**Re: Defect Information Report – Supplemental Report No. 1
11V-330, FL-609, Starter Cable Isolator Bolts
Interim Dealer Bulletin**

August 2011
FL609
NHTSA #11V-330
Transport Canada #11-236
INTERIM RECALL BULLETIN

Subject: Starter Cable Isolator Bolts

Fig. 1, Correct Isolator Installation

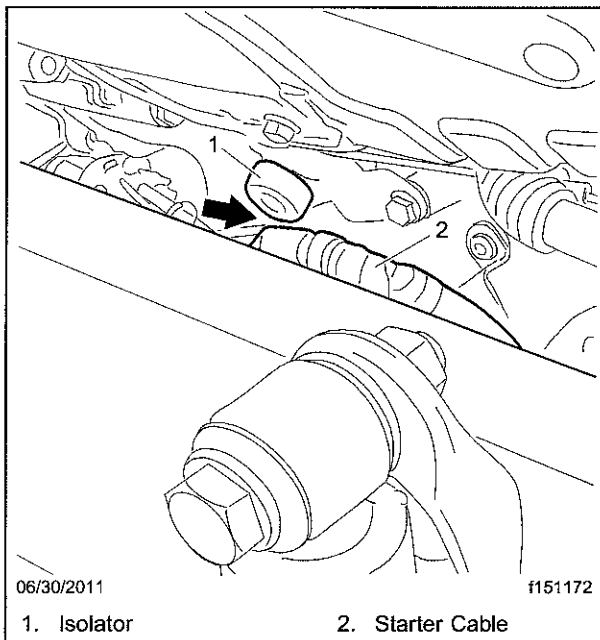
If the bolt is present and there is a minimum of 1/2-inch of clearance between the isolator and the starter cable, no further action is necessary at this time. See Fig. 1.

4. Apply Loctite 272 high temperature thread-locking compound to the capscrew threads, then install the capscrew and the isolator, tightening the capscrew until the rubber isolator begins to compress. The mounting capscrew should not protrude past the front surface of the isolator, and there must be approximately 1/2-inch (13 mm) of clearance between the isolator and the starter cable. See **Fig. 1** and **Fig. 2**.
5. Connect the batteries.
6. Remove the chocks from the tires.

Fig. 2, Bolt Backed Out

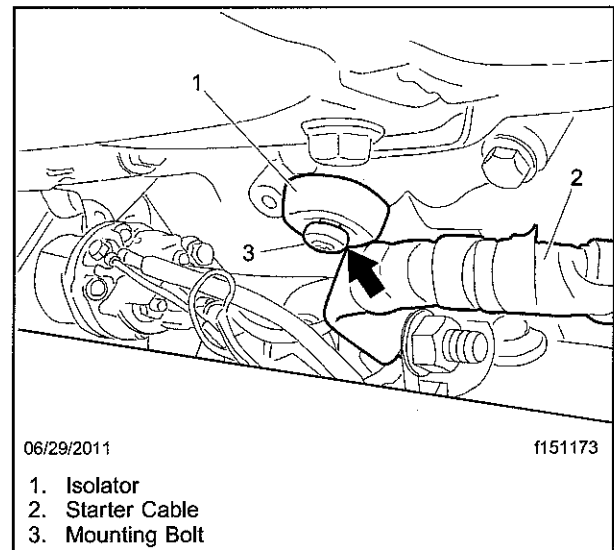
If the bolt has backed out of the isolator and is protruding past the front surface of the isolator or if the starter cable is within 1/2-in of the isolator, take the vehicle to an authorized Daimler Trucks North America dealer for repair. See Fig. 2.

3. Locate the rubber isolator mounted to the side of the engine on the right-hand side of the vehicle. See **Fig. 1** and **Fig. 2**. Remove the capscrew and isolator.
